Illinois Tollway Base Sheet Revisions

| Section M Base Sheet Drawings | | |
| Drawing | Modification Summary | Effective: 03-01-2019 |

COLUMN BASE PLATE PLAN
SEE NOTE 5

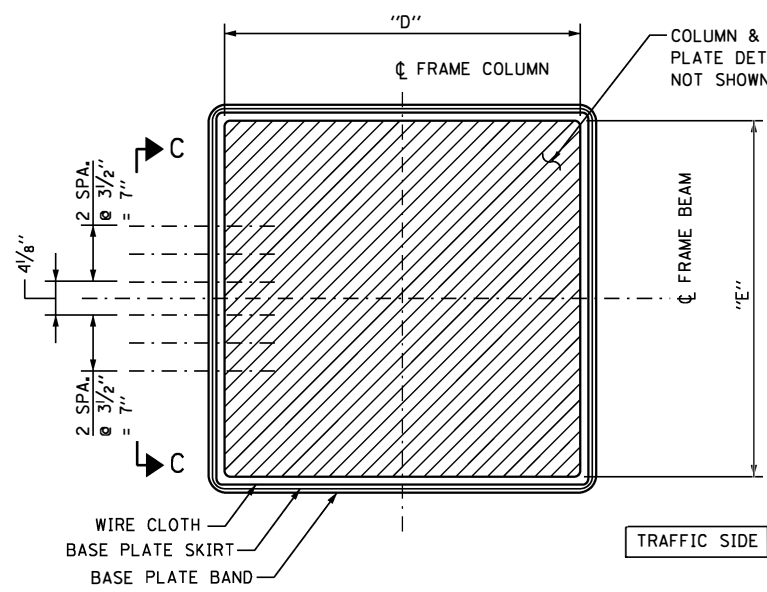
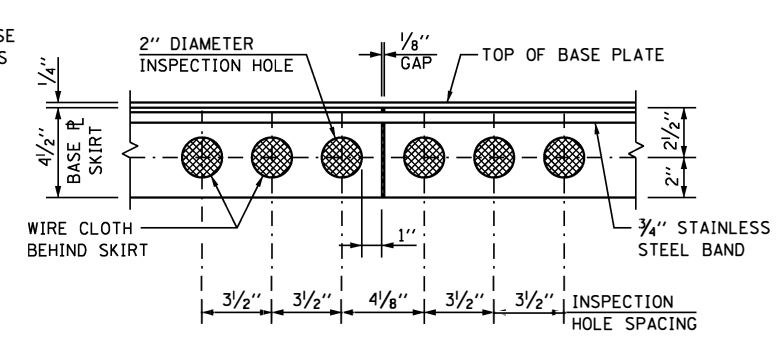
| Section M Base Sheet Drawings | | |
|---------------------------------------|-------------------------------------------------------------------------------------------------------------------------|------------------------------|
| M-OHS-729 | OVERHEAD SIGN STRUCTURE ITS GANTRY FRAME (STEEL) SINGLE-SPAN STRUCTURE DETAILS SHEET 2 | |
| | Increase base plate opening so that the 6" typ. Dimension in the Base Plate Plan is now 3" typ. | |
| | Increase base plate thickness to 3" to accommodate a larger opening | |
| | Revised Structure Design Manual and Geotechnical Engineering Manual to the latest editions | |

BASE DRAWING M-OHS-729
SHEET 3 OF 8

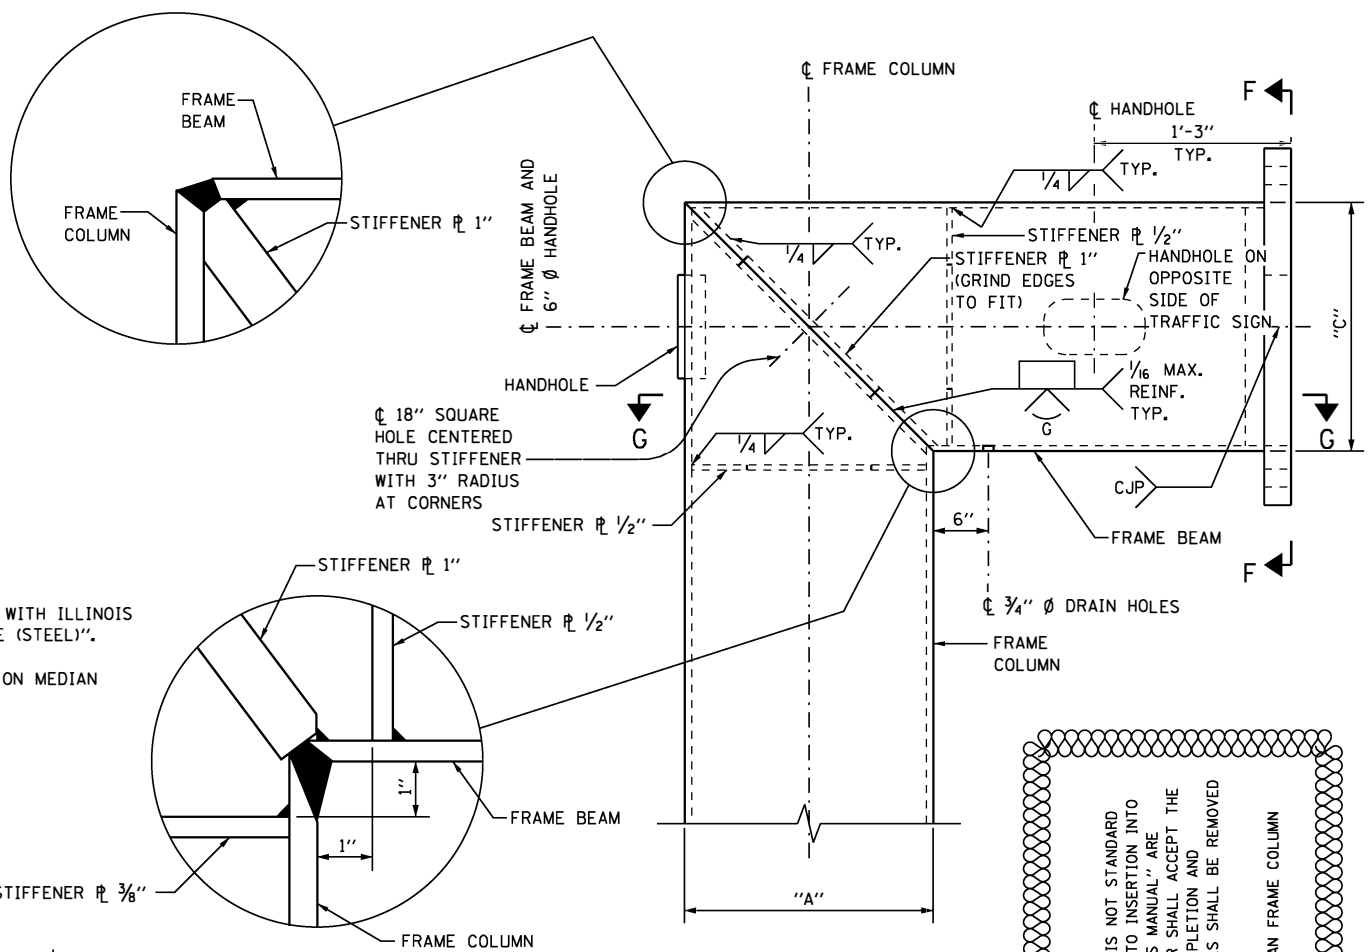
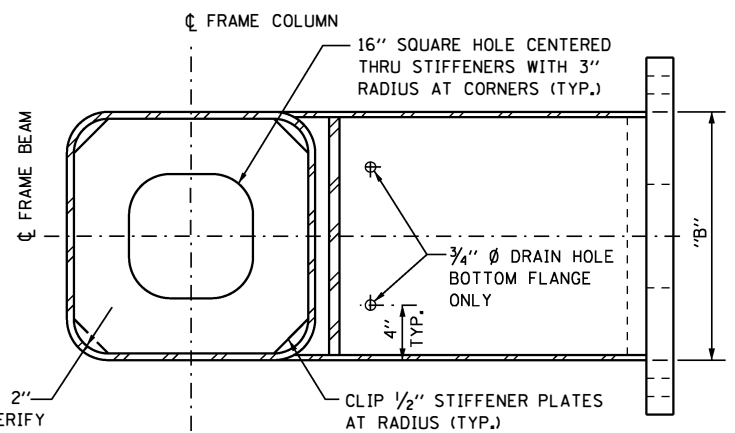
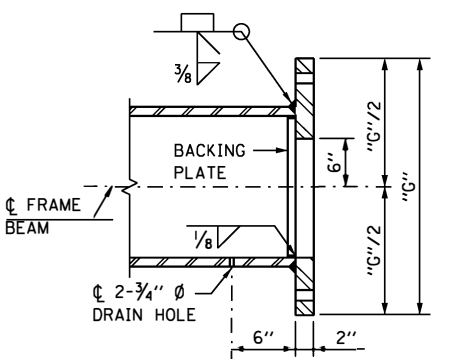
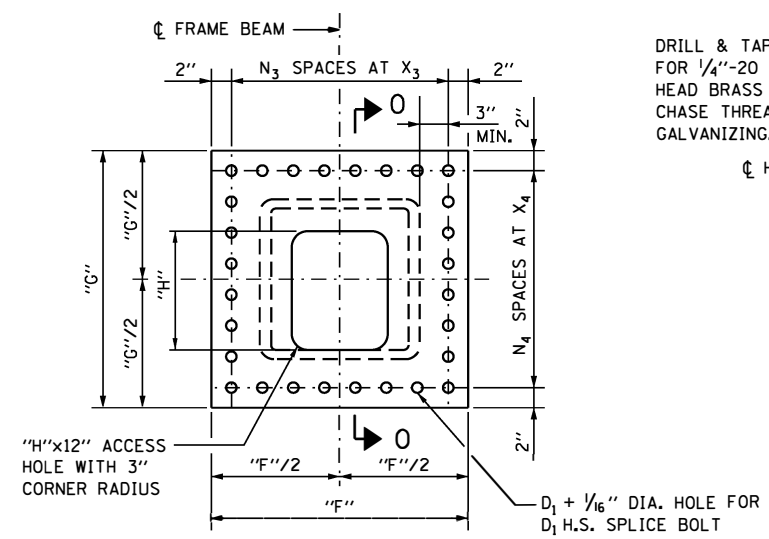
| Section M Base Sheet Drawings | | |
|---------------------------------------|-------------------------------------------------------------------------------------------------------------------------|------------------------------|
| M-OHS-729 | OVERHEAD SIGN STRUCTURE ITS GANTRY FRAME (STEEL) SINGLE-SPAN STRUCTURE DETAILS SHEET 3 | |
| | Increase the opening in the splice plate so that the bottom is in line with the bottom of the horizontal frame beam | |
| | Increase opening of corner stiffener plate from 12" to 18" square hole and thickness from 3/4" to 1" | |
| | Increase opening of horizontal and vertical stiffener plate from 12" to 16" square hole and thickness from 3/8" to 1/2" | |
| | Increase handhole detail size from 7.5"x12" to 9"x12" | |

BASE DRAWING M-OHS-729
SHEET 8 OF 8

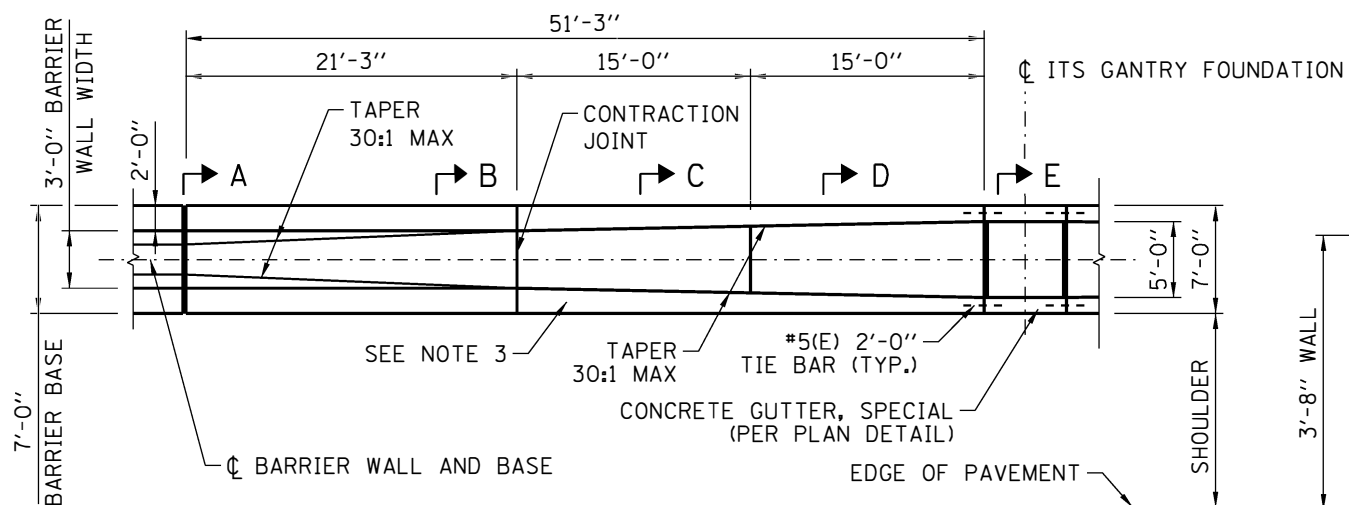
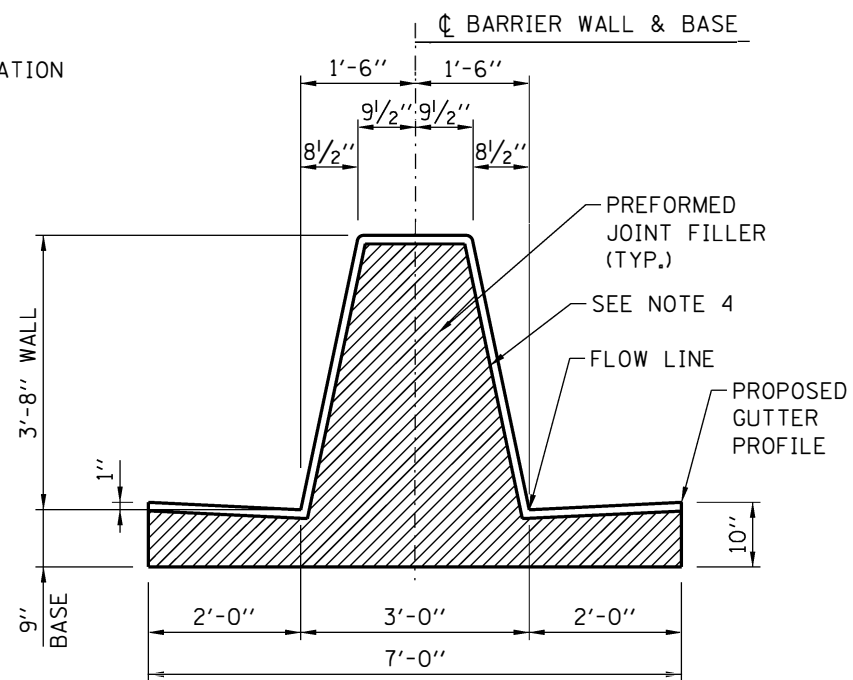
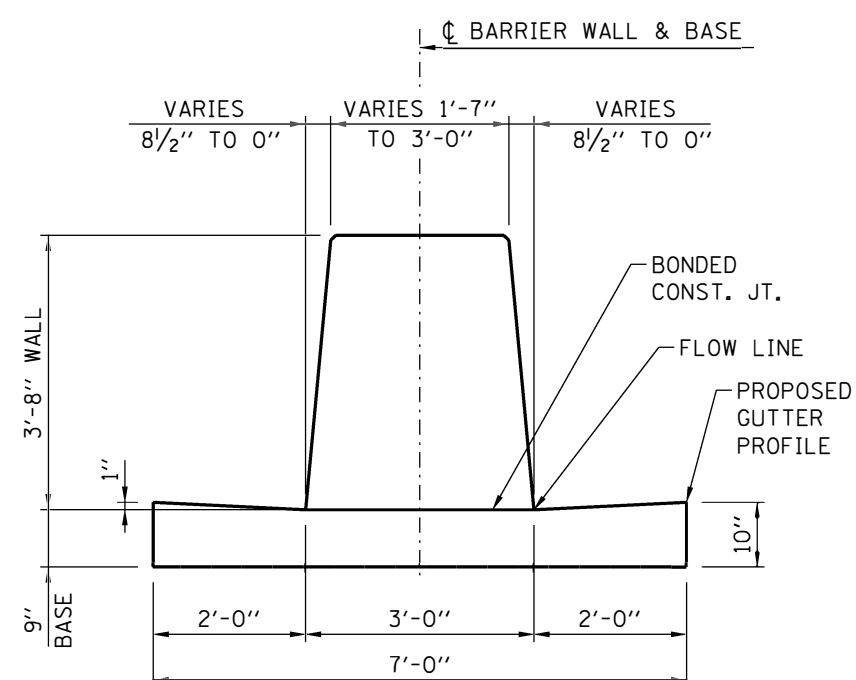
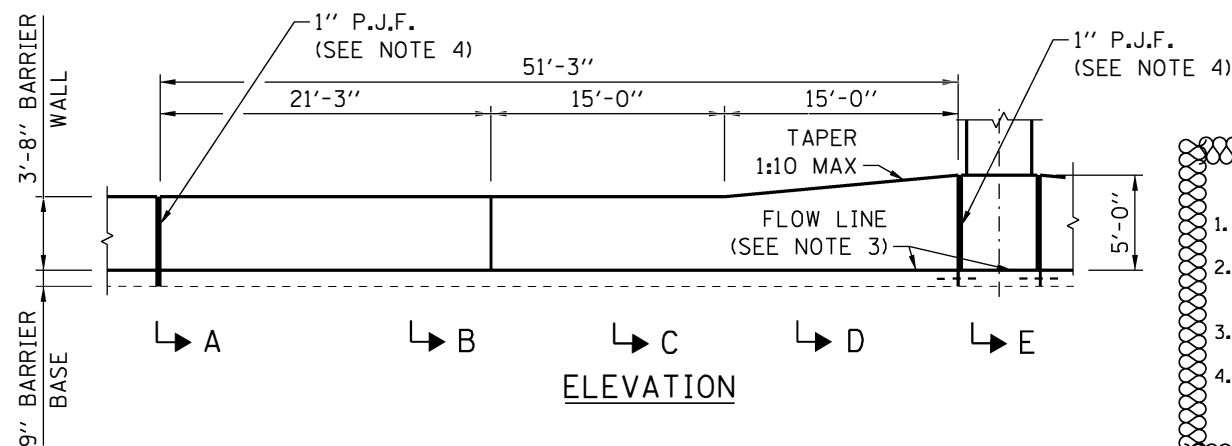
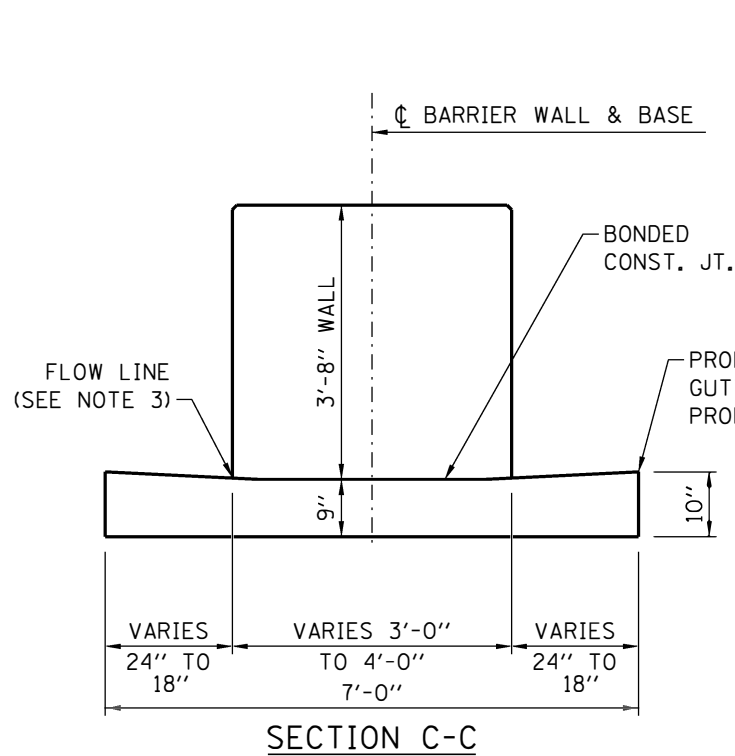
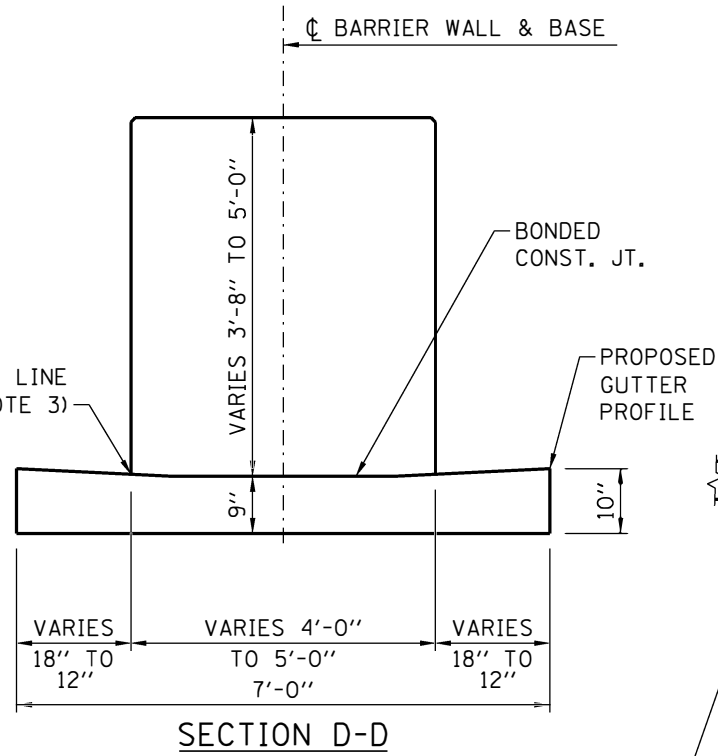
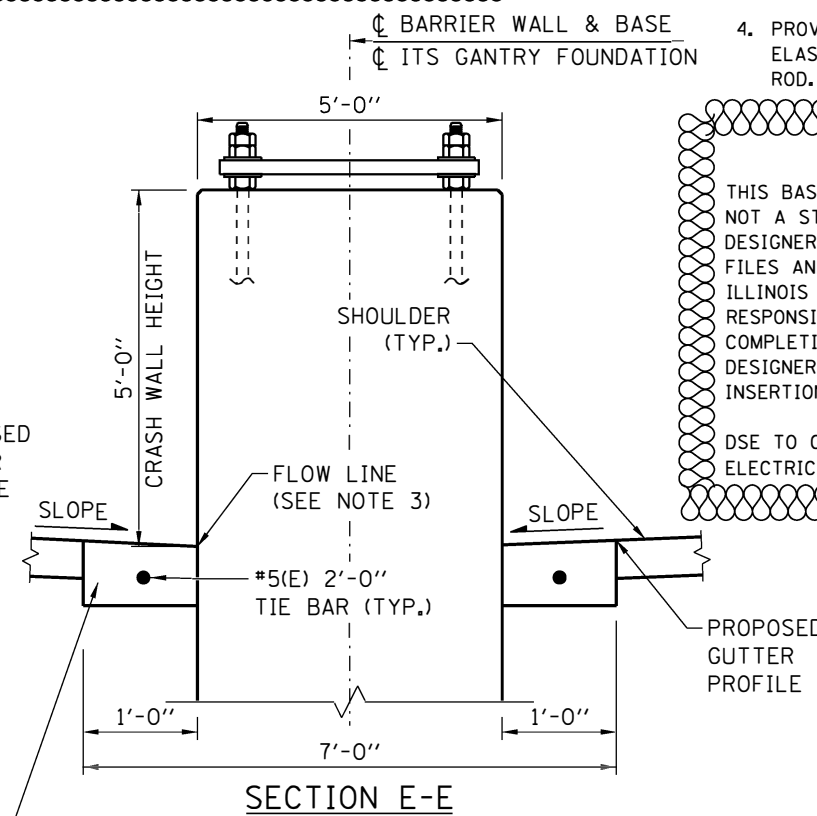
| Section M Base Sheet Drawings | | |
|---------------------------------------|-------------------------------------------------------------------------------------------------------------------------|------------------------------|
| M-OHS-729 | OVERHEAD SIGN STRUCTURE ITS GANTRY FRAME (STEEL) SINGLE-SPAN STRUCTURE DETAILS SHEET 8 | |
| | Update barrier shape and details for constant slope | |

COLUMN BASE PLATE PLAN

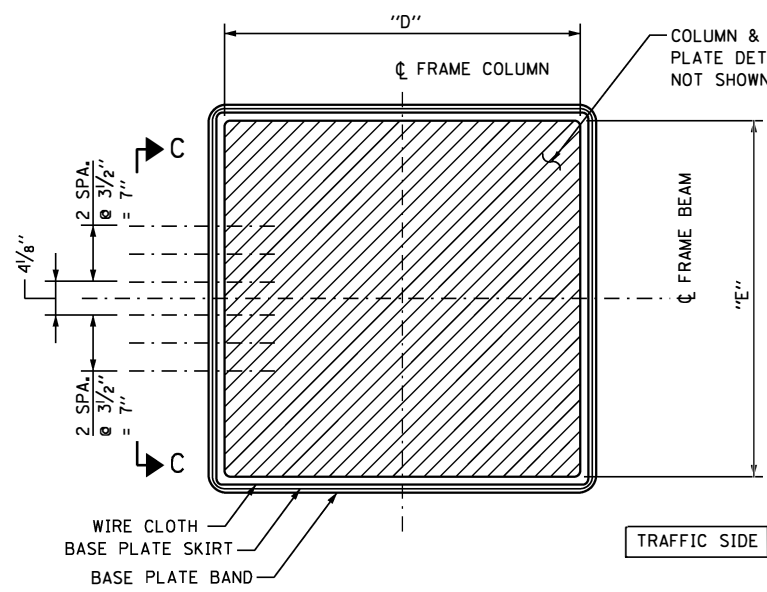
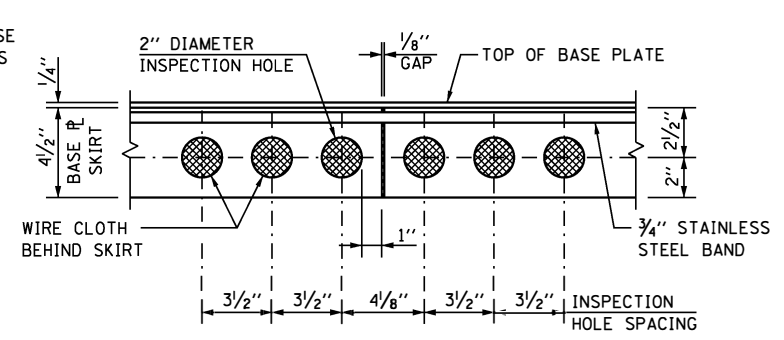
| Section M Base Sheet Drawings | | |
|---------------------------------------|-------------------------------------------------------------------------------------------------------------------------|------------------------------|
| M-OHS-730 | OVERHEAD SIGN STRUCTURE ITS GANTRY FRAME (STEEL) TWO-SPAN STRUCTURE DETAILS SHEET 2 | |
| | Increase base plate opening so that the 6" typ. Dimension in the Base Plate Plan is now 3" typ. | |
| | Increase base plate thickness to 3" to accommodate a larger opening | |
| | Revised design specifications to the latest editions | |
| | Added IDOT to reference to the Standard Specification in reinforcement bars note 1 | |

VIEW D-D
HANDHOLE DETAIL

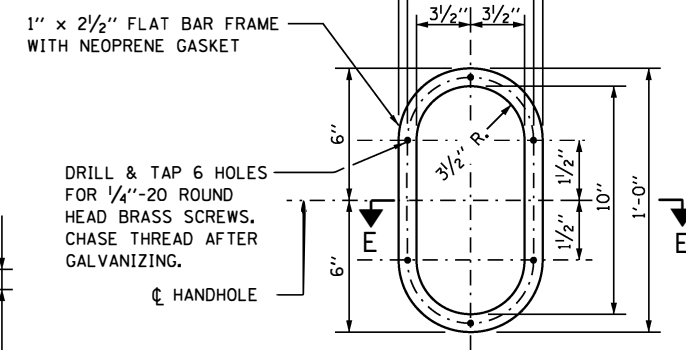
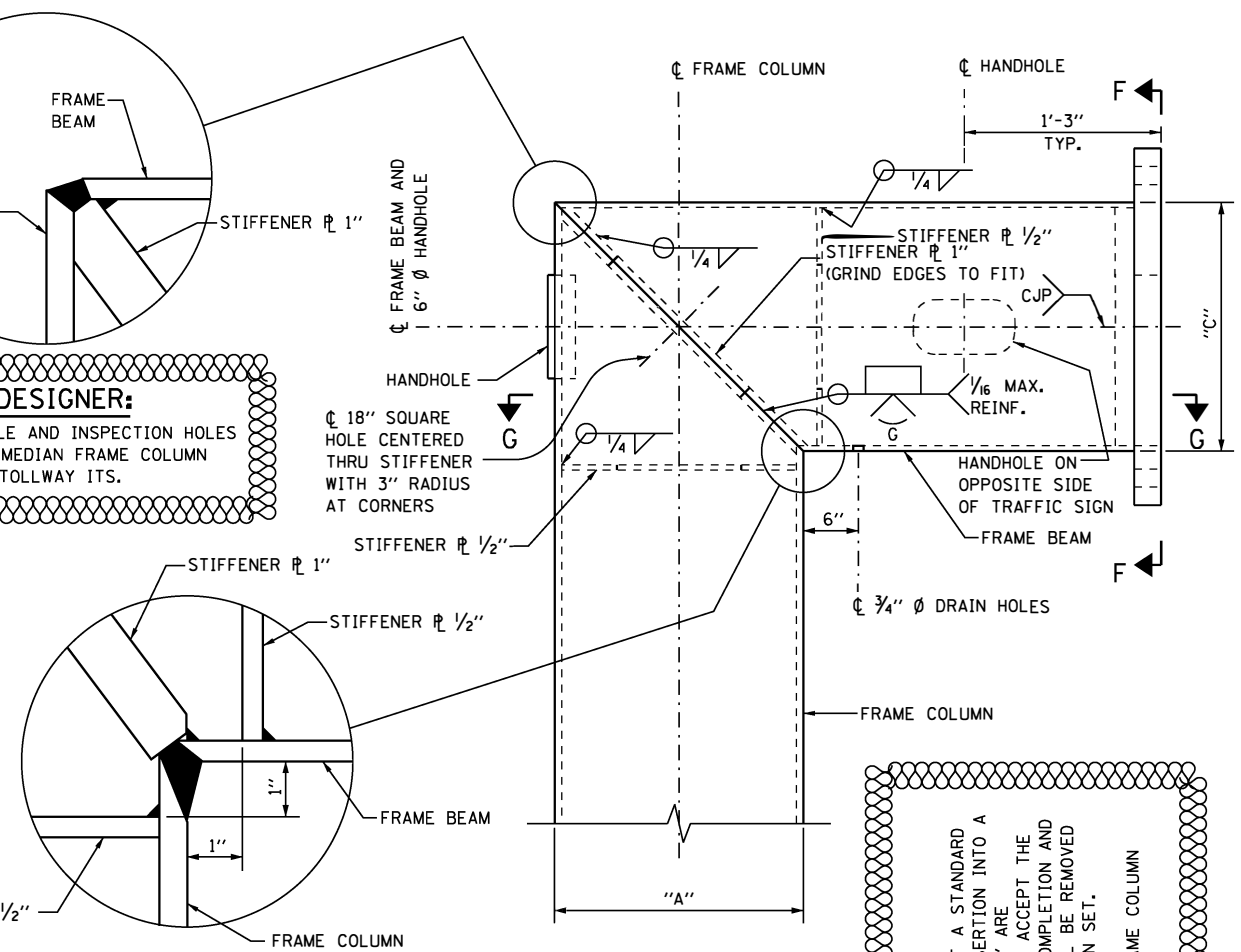
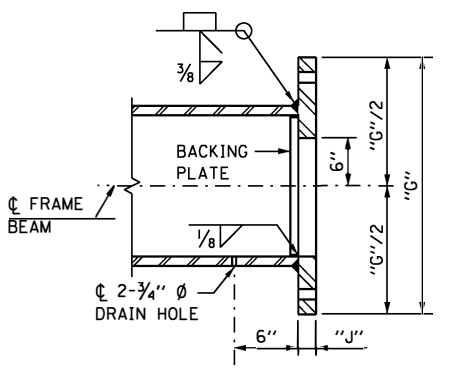
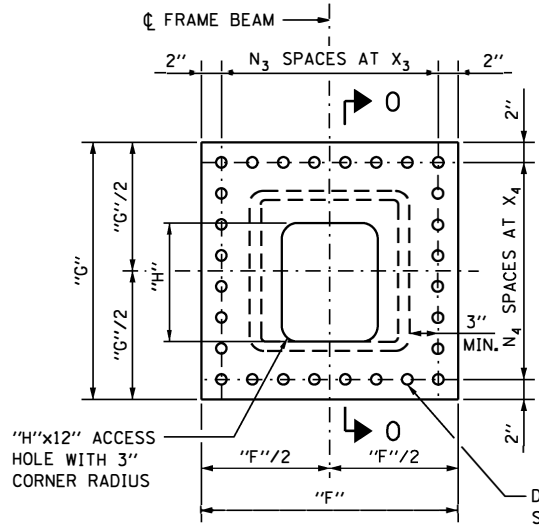
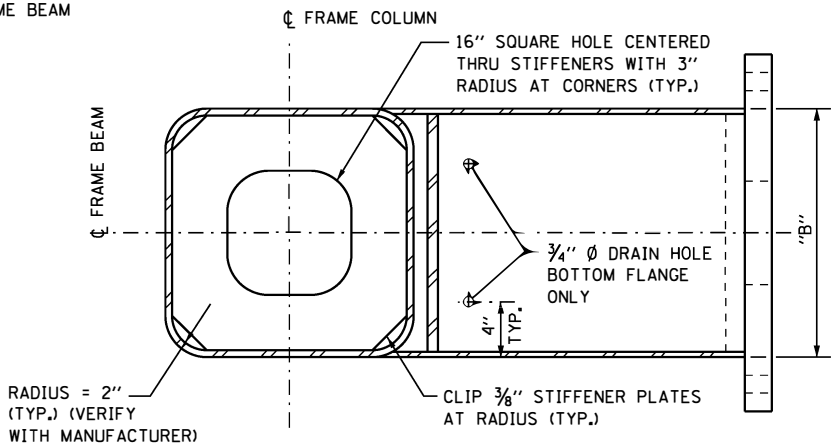
| Section M Base Sheet Drawings | | |
|---------------------------------------|-------------------------------------------------------------------------------------------------------------------------|------------------------------|
| M-OHS-730 | OVERHEAD SIGN STRUCTURE ITS GANTRY FRAME (STEEL) TWO-SPAN STRUCTURE DETAILS SHEET 3 | |
| | Increase the opening in the splice plate so that the bottom is in line with the bottom of the horizontal frame beam | |
| | Increase opening of corner stiffener plate from 12" to 18" square hole and thickness from 3/4" to 1" | |
| | Increase opening of horizontal and vertical stiffener plate from 12" to 16" square hole and thickness from 3/8" to 1/2" | |
| | Increase handhole detail size from 7.5"x12" to 9"x12" | |
